Re : Section 72 application - Maribyrnong City Council - Planning Application TP268/2021(2)
At : 379 Geelong Rd, 1A Lewis St, 1 Lewis St KINGSVILLE

Response to Town planning RFI letter dated 2 April 2024

TOWN PLANNING SUBMISSION

1 & 1A LEWIS STREET & 379 GEELONG ROAD, KINGSVILLE

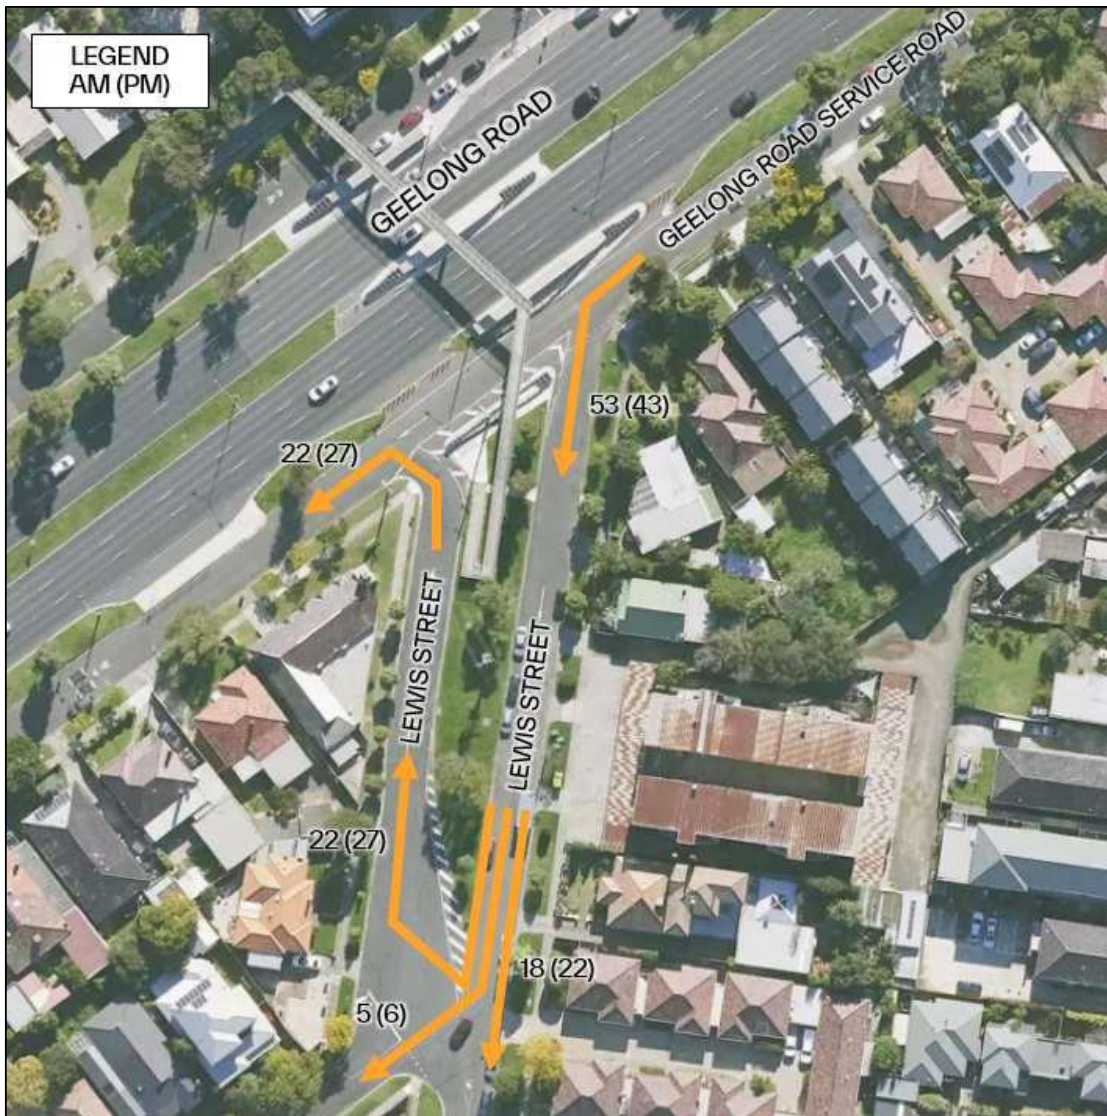
- *The U-turn movement on Lewis Street to access Geelong Road service lane is approximately 45m from the proposed crossover, and can create congestion/queuing in the peak hours;*

The proposed crossover to service the site is provided in an optimum location and well clear of the Geelong Road intersection. In addition, the number of movements expected to perform a U-turn along Lewis Street to access Geelong Road Service Road is reasonably low (as detailed further below) and is not expected to create any adverse traffic safety or operational issues.
